SERVICE BULLETIN

SUBARU CORPORATION
Customer Quality Dept.
Japan.

Issued: 9 March, 2022
Rev.1 25 July, 2022

Subject:	Repair Procedure Change: Repair Procedure against the squeaking noise from UNIVERSAL JOINT ASSEMBLY-STEERING
Applicable Section in Service Manual:	STEERING COLUMN > SYSTEM > Steering Intermediate Shaft Steering > POWER ASSISTED SYSTEM (POWER STEERING) > Universal Joint
Applicable Parts Name in Parts System:	Steering System and Cable > MANUAL STEERING GEAR BOX > UNIVERSAL JOINT ASSEMBLY-STEERING
Foreword:	This Service Bulletin is to inform you of the repair procedure against the squeaking noise from UNIVERSAL JOINT ASSEMBLY-STEERING that occurs when steering wheel is rotated. Rev.1: Added production change and new parts information.

4. Working Procedure (Grease Application Procedure)

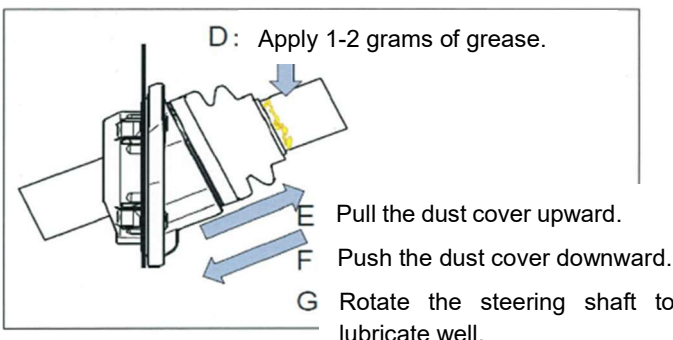
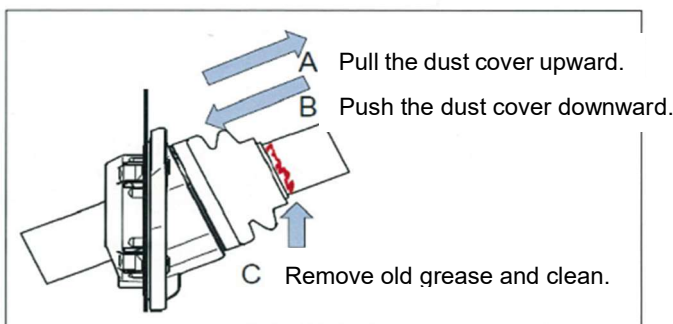
Symptom	Details of Symptom and Countermeasure
A squeaking noise occurs when steering wheel is rotated.	<p>Details of Symptom: A squeaking noise occurs from UNIVERSAL JOINT ASSEMBLY-STEERING when steering wheel is rotated. This is due to the lack of lubrication at the friction surface of the UNIVERSAL JOINT ASSEMBLY-STEERING dust seal. (Deteriorated grease created the lack of lubrication condition.)</p> <p>Countermeasure: The problem can be solved by adding 1-2 grams of grease to the UNIVERSAL JOINT ASSEMBLY-STEERING dust seal. For the production line, new UNIVERSAL JOINT ASSEMBLY-STEERING that contains new grease NIGLUBE RM inside is introduced.</p> <p>When the problem is reported, apply grease to the dust seal. (See 5. Working Procedure.)</p>

- A. Pull the dust cover upward.
- B. Push the dust cover downward.
The above procedure A and B are to collect old grease.
- C. Remove old grease and clean.
- D. Apply 1-2 grams of grease around the shaft.
Recommended grease:
NIGLUBE RX-2 or equivalent
- E. Pull the dust cover upward.
- F. Push the dust cover downward.
The above procedures E and F are to spread the grease well.
- G. Rotate the steering shaft to lubricate well.

Note:

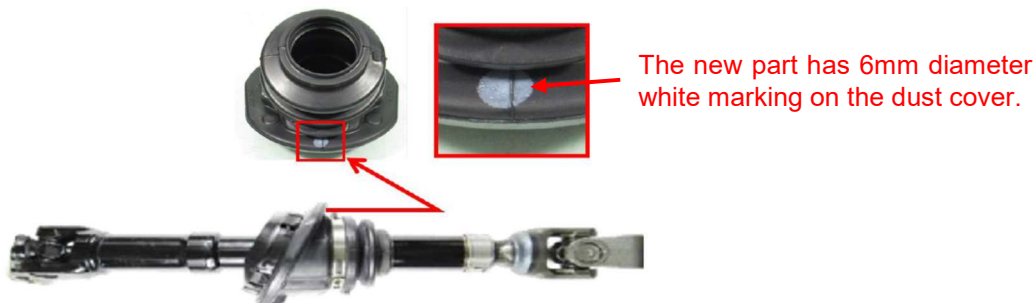
The old parts and new parts use different grease. (Old: NIGLUBE RX-2 New: NIGLUBE RM)
When lubrication the steering shaft, use appropriate grease. (Do not mix NIGLUBE RX-2 and NIGLUBE RM.)
See the below photos to identify old part or new part.
